H. B. ROBINSON STEAM ELECTRIC PLANT, UNIT NO. 2
DOCKET NO. 50-261/LICENSE NO. DPR-23
SUPPLEMENTAL INFORMATION RELATED TO REQUEST FOR RELIEF TO
IMPLEMENT A TEMPORARY NON-CODE REPAIR

ENCLOSURE
SUPPLEMENTAL INFORMATION RELATED TO THE OCTOBER 14, 1994 REQUEST
FOR RELIEF TO IMPLEMENT A TEMPORARY NON-CODE REPAIR

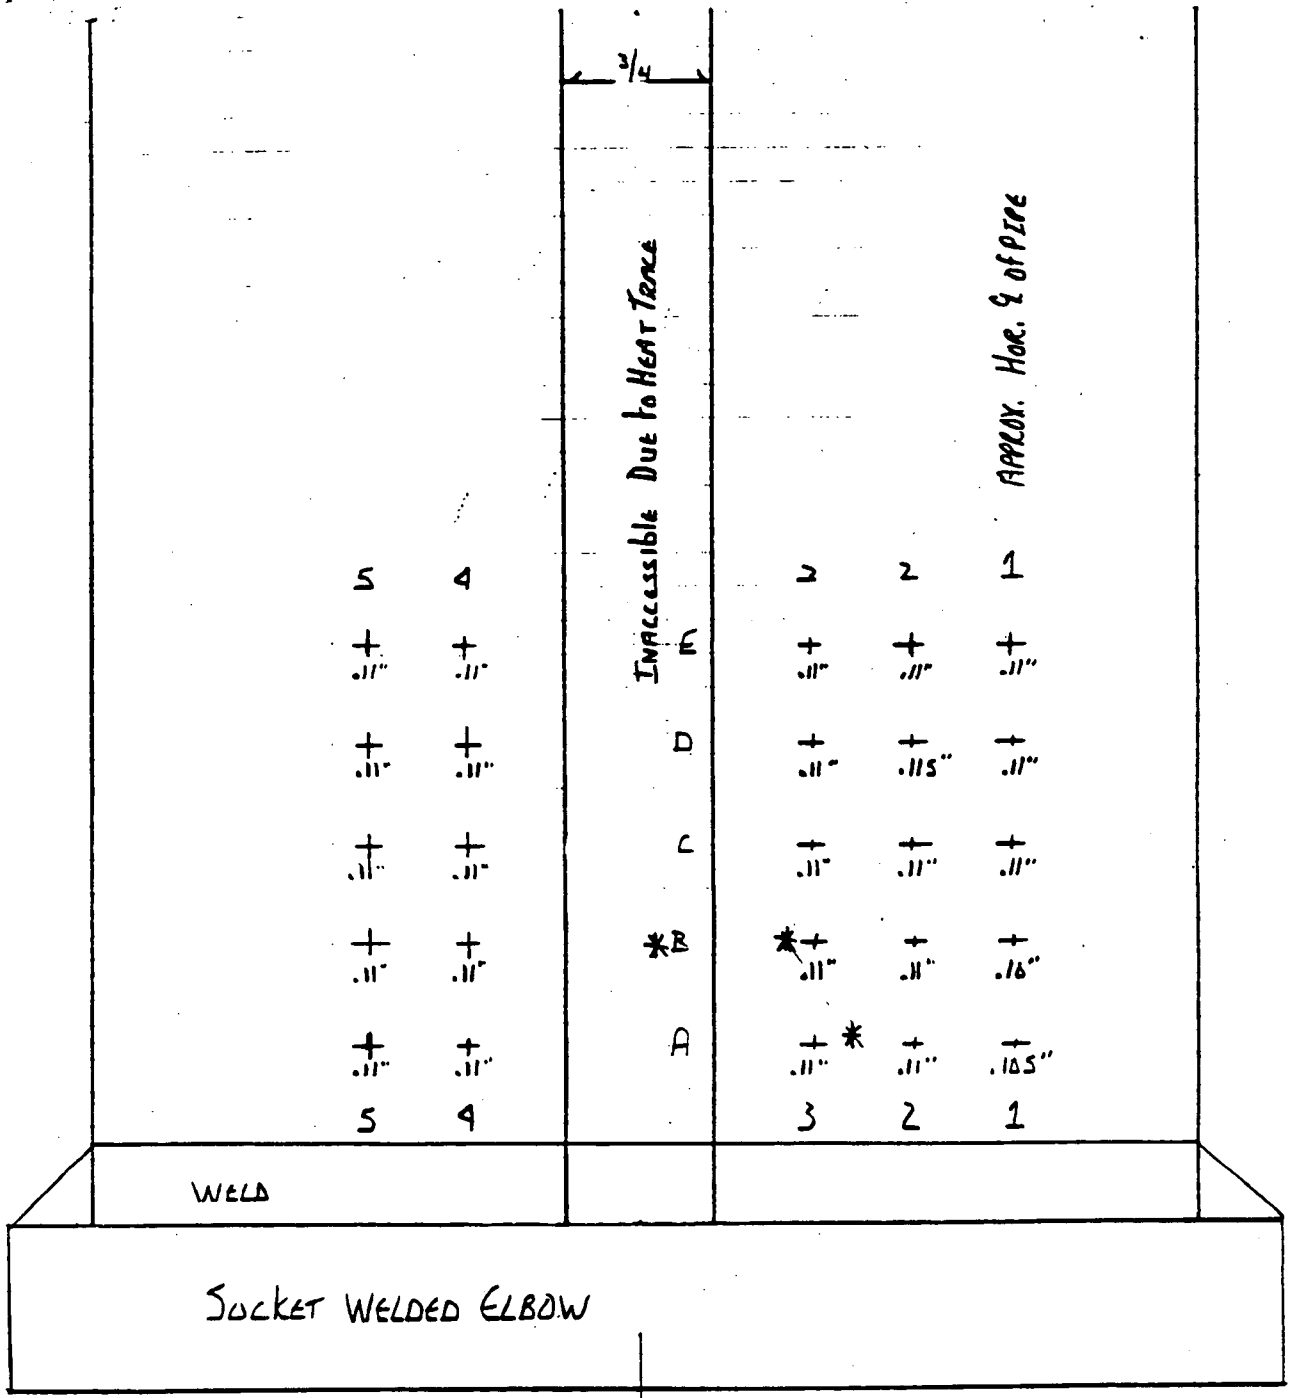
(1) Provide a plot of the site that was ultrasonically tested.

A plot showing the site that was ultrasonically tested is attached.
